**Addendum No. 1**

**Subject: J. Hampton Moore School  
Major Renovation Phase 2B – Interior Renovations  
SDP Contracts No. B-083C and B-084C of 2016/17**

**Location: J. Hampton Moore School  
1100 Tyson Avenue  
Philadelphia, PA 19111**

**This Addendum, dated 7th of November, 2017, shall modify and become part of the Contract Documents for the work of this project. Any items not mentioned herein, or affected by, shall be performed strictly in accordance with the original documents.**

DRAWING NO.  
**FA.01**  
J. HAMPTON MOORE SCHOOL

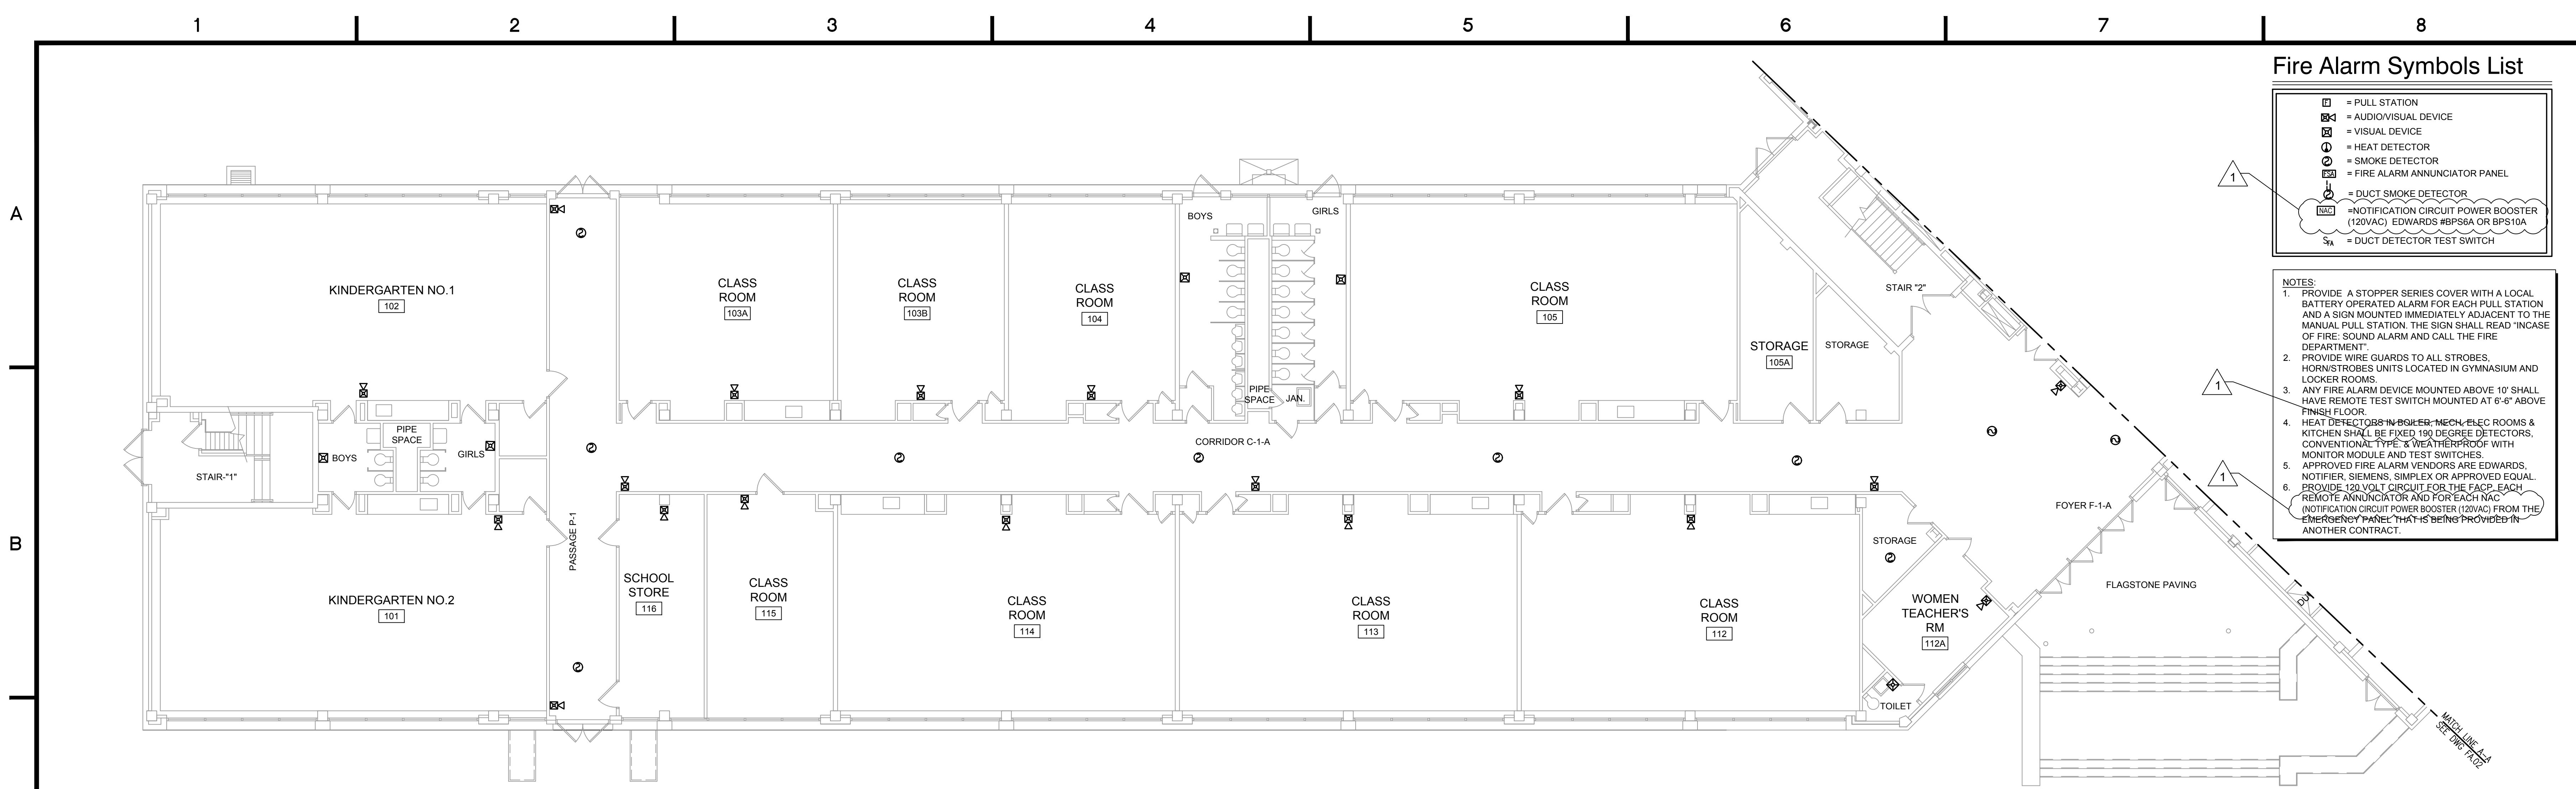
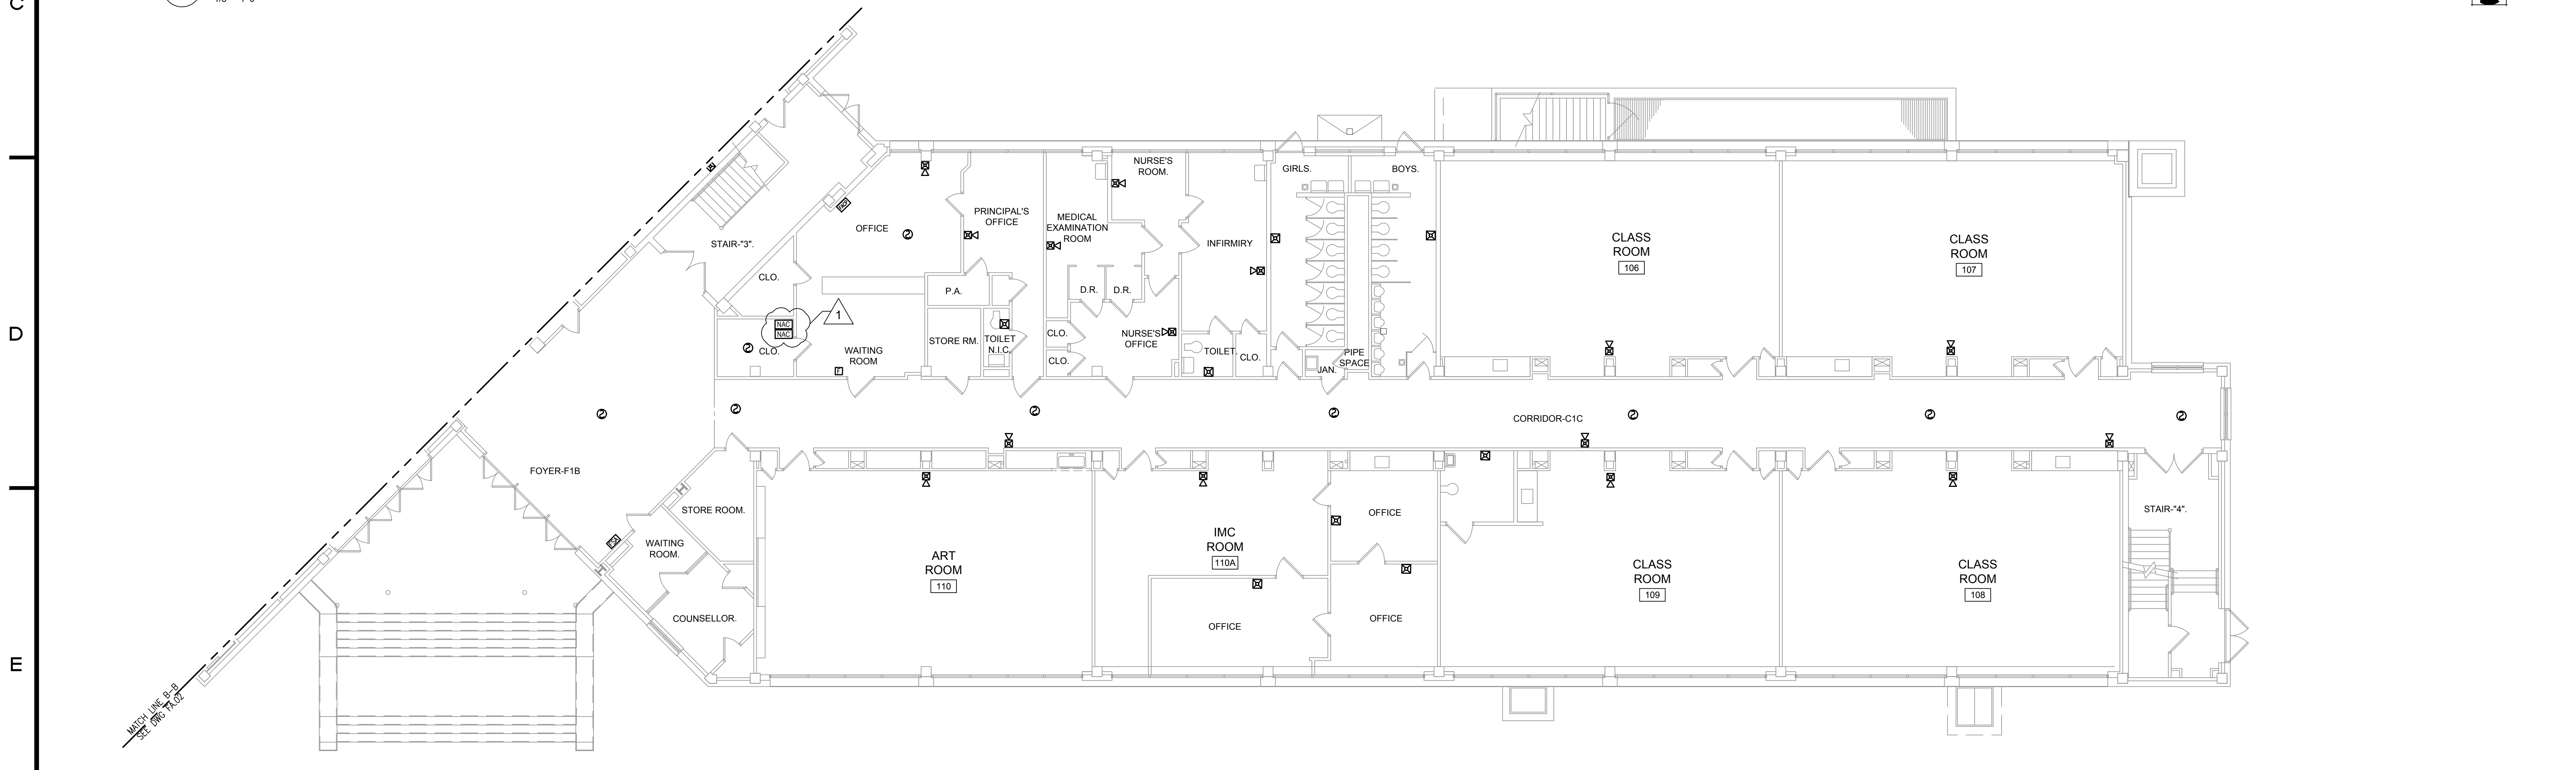
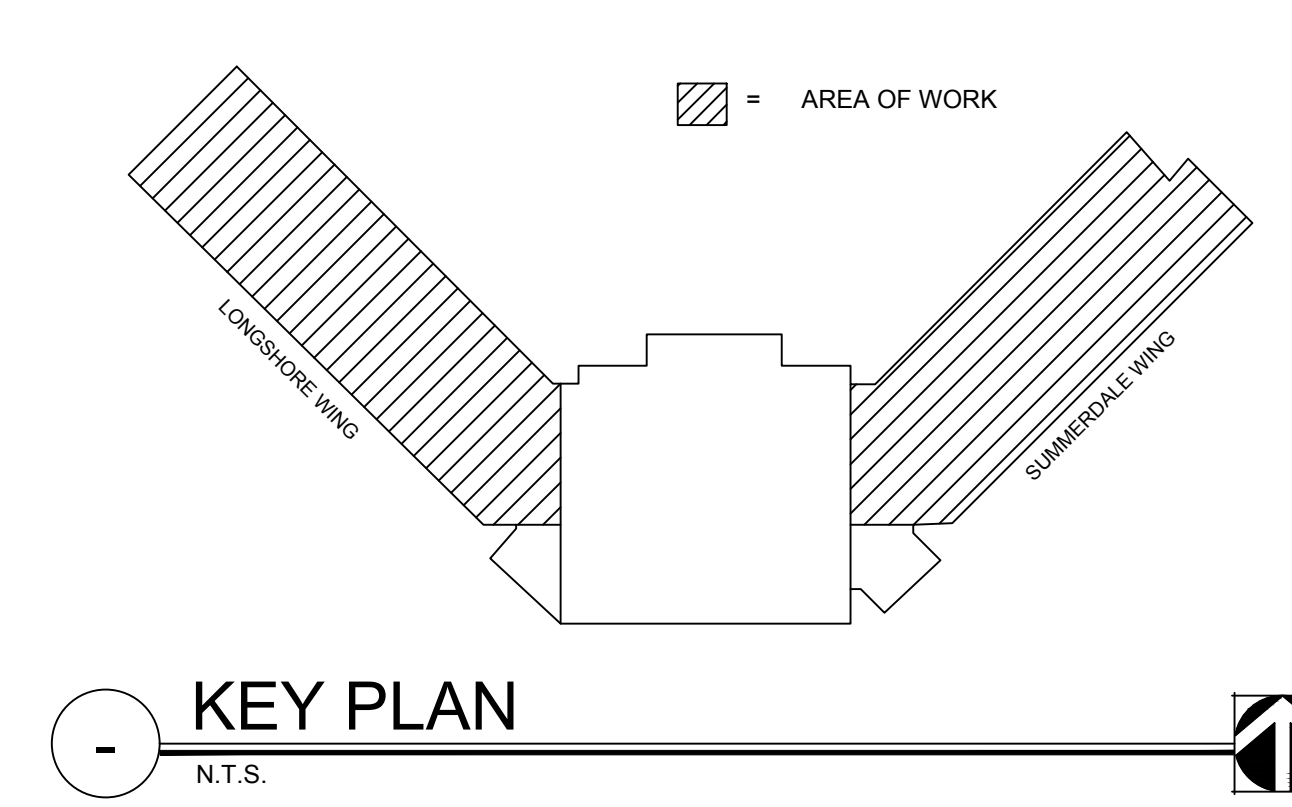
- 1. Drawing E2.02 is revised to include PA speakers and wireless clocks in the new modular building. The modular building is provided by others and is not part of this project.**
- 2. Drawing E5.04 – Detail 3 mounting detail is modified to include power/control cable.**
- 3. Drawing E6.01 – PNL L main rating changed to 225A; PNL L breaker at MDP2 changed to 175A; feeders from MDP2 to PNL L changed to 4 #2/0 & 1-#6 Gnd.**
- 4. Drawings FA.01 thru FA.04 – Notification circuit power booster (NAC) added to symbol legend; Location of NAC have been indicated on plans; Note 4 and 6 have been modified.**

5. APPROVED FIRE ALARM VENDORS ARE EDWARDS, NOTIFIER, SIEMENS, SIMPLEX OR APPROVED EQUAL.
  6. PROVIDE 120 VOLT CIRCUIT FOR THE FACP. EACH REMOTE ANNUNCIATOR AND FOR EACH IAC (NOTIFICATION CIRCUIT POWER BOOSTER (120VAC) FROM THE EMERGENCY PANEL THAT IS BEING PROVIDED IN ANOTHER CONTRACT.
